MECKLENBURG COUNTY
DEPARTMENT OF ENVIRONMENTAL HEALTH

SITE INVESTIGATION REPORT
INDIVIDUAL SEPTIC TANK SYSTEM
WITH SUBSURFACE,
SOIL ABSORPTION,
EFFLUENT DISCHARGE

S.I.R. # 16421

LOCATION OF LOT Brickstone Drive (parcel #07), Lot 98

* See Diagram on Back (Include: Soil areas, property lines, roads, streams, gullies wet areas, fill areas, wells, water bodies, slope patterns, etc

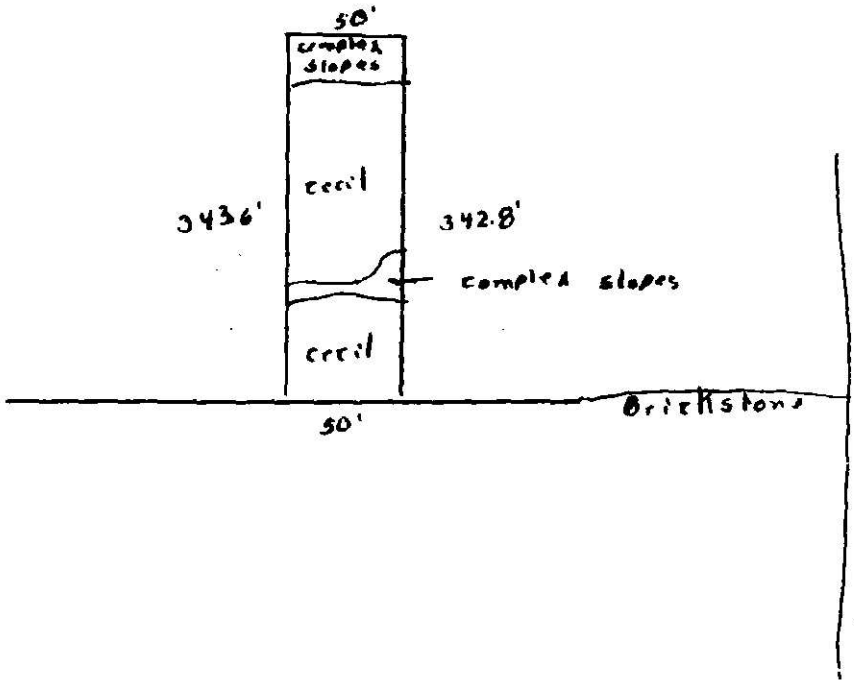
FACTORS	AREA 1	AREA 2	AREA 3	AREA 4
1. SLOPE (%)	(S) PS U 2-8%	S PS (U) complex slopes exceed	S PS U	S PS U +
2. SOIL TEXTURE (12-36 in.) (Sandy, loamy clayey, Note 2 1 Clay)	S (PS) clay U	S (PS) clay U	S PS U	S PS U
3. SOIL STRUCTURE (12-36 in.) (Clayey Soils)	S (PS) Blocky U	S (PS) Blocky U	S PS U	S PS U
4. SOIL DEPTH (In.)	(S) PS U 40"	S Depth PS Variable (U)	S PS U	S PS U
5. RESTRICTIVE HORIZONS (In.) (Impervious Strata Rock)	(S) None PS U	(S) None PS U	S PS U	S PS U
6. SOIL DRAINAGE/GROUNDWATER (External & internal)	(S) PS U 76" to groundwater	S Eroded PS Areas (U) channel water	S PS U	S PS U
7. SOIL PERMEABILITY (Percolation Rate)	S (PS) Moderate U	S (PS) Moderate U	S PS U	S PS U
8. OTHER (Specify)	S Inadequate PS Area (U) < 20,000 sq. Ft.	S PS	S PS U	S PS U
9. SITE CLASSIFICATION	unsuitable	unsuitable		
SOIL SERIES	Cerri	complex slopes Exidal

Recommendations/Comments

50'
complex slopes
cecil
342.8'
complex slopes
cecil
50'
Brickstone

3 PLOT PLAN (ACCURATELY DIMENSIONED)

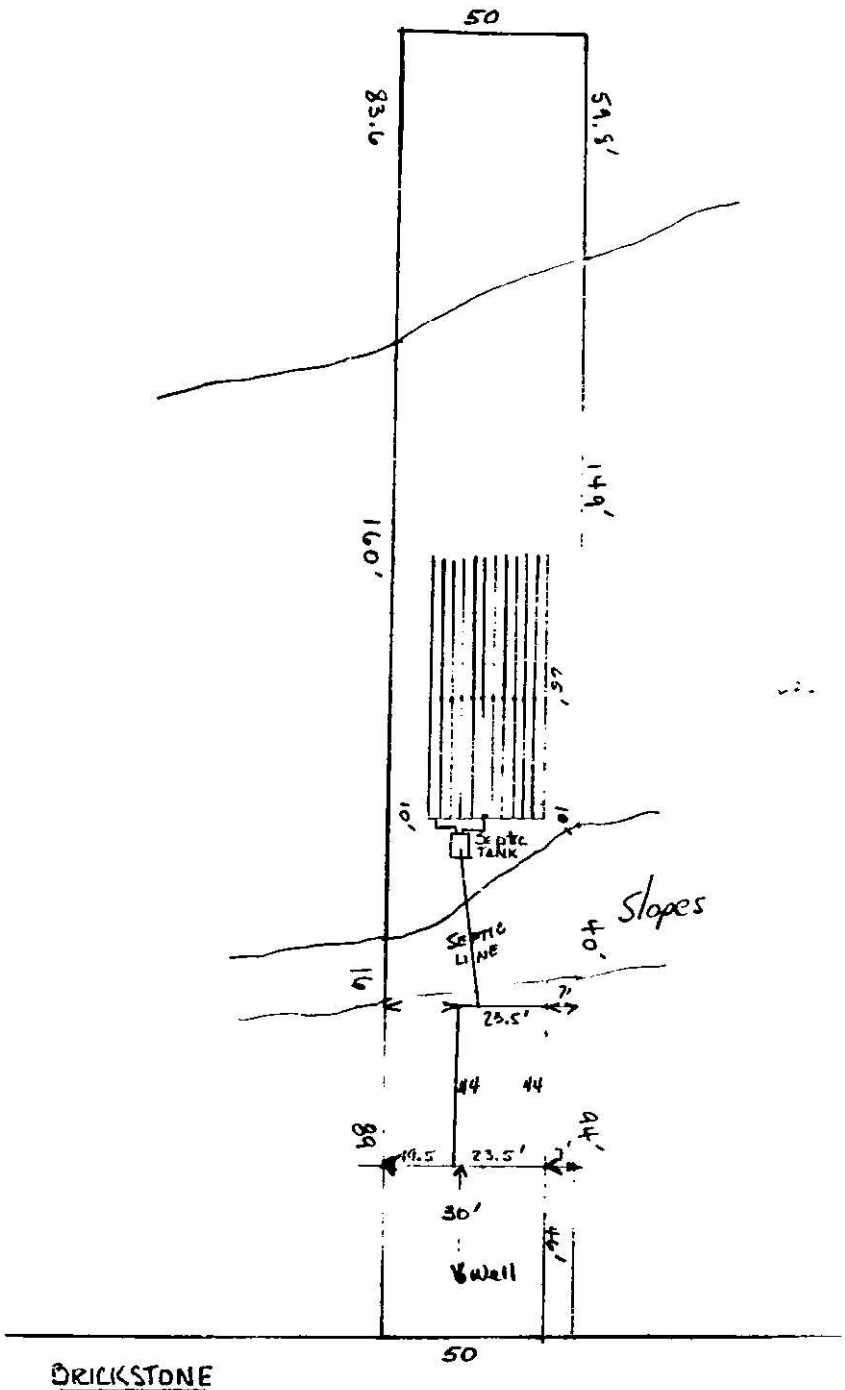
As determined under the Rules and Regulations promulgated by the Commission for Health Services, Division of Health Services, North Carolina Department of Human Resources, Raleigh, North Carolina, the soils on the lot described above were found to be unsuitable for the installation of an individual septic tank - soil absorption system, due to the following reason:

Limited area of provisionally suitable soils.

Please submit plot indicating location of proposed residence and sewage disposal system.

The above specified lot is approved by the Mecklenburg County Department of Environmental Health for the installation of an individual septic tank system with subsurface, soil absorption, effluent discharge based on the soil investigation, on an on-site inspection of the said lot; and upon the information supplied in the "Application for an Installation, Construction, Alteration, and/or Repair Permit", number 16421. This approval is subject to the following terms and conditions:

1. That the nitrification field be installed, constructed, altered and/or repaired in the same area where the soil investigation was run
2. That an "Installation, Construction, Alteration and/or Repair Permit" be issued and in full force and effect when the system is installed constructed, altred, and, or repaired and that the system be installed in accordance with same
